**From:** [Diane Abbott](#)  
**To:** [Oaklands Farm Solar](#)  
**Subject:** Further Submissions  
**Date:** 23 October 2024 14:58:11  
**Attachments:** [Oaklands NSIP submission 30-04-24 corrected.pdf](#)  
[Comments for open hearing.pdf](#)  
[Visualisation feedback.pdf](#)

Please find attached my prepared notes in response to the Applicants comments with relation to Landscape Visualisations.

## **Oakland's Solar – NSIP letter**

Figs 11b & c (Cross Britain Way looking roughly North)

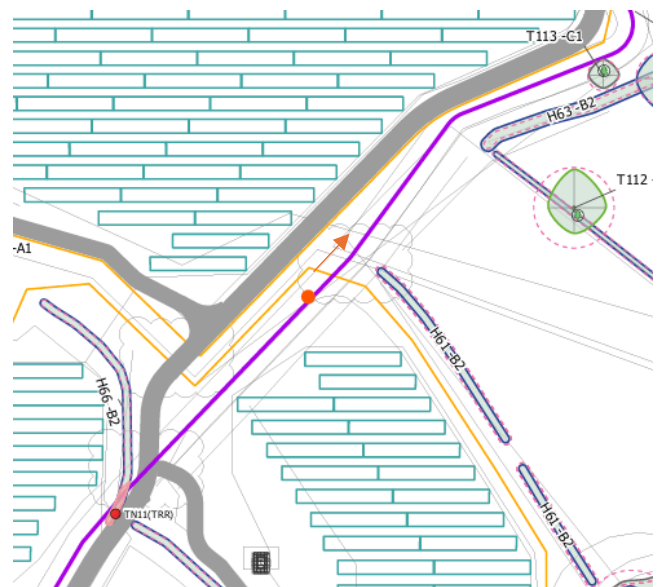
The Applicant’s state that all items are modelled at the correct scale, but provide no evidence.

A site visit, taking photographs of a calibrated height marker at different positions in the field would be a simple way of clarifying the accuracy of the rendered visualisation.

The Applicant’s visualisation fails to show the full 6m access track running in front of the solar panels, nor does it show the security fencing that will be needed on either side of the PRow (approx. 5m between fences).

The fence and solar panels on the left side of the visualisation seem to be modelled much further away from the camera than the hedge on the right, but, as they are similar distances from the central camera position, they should show the same perspective.

As before, I remain sceptical about the accuracy of this visualisation.
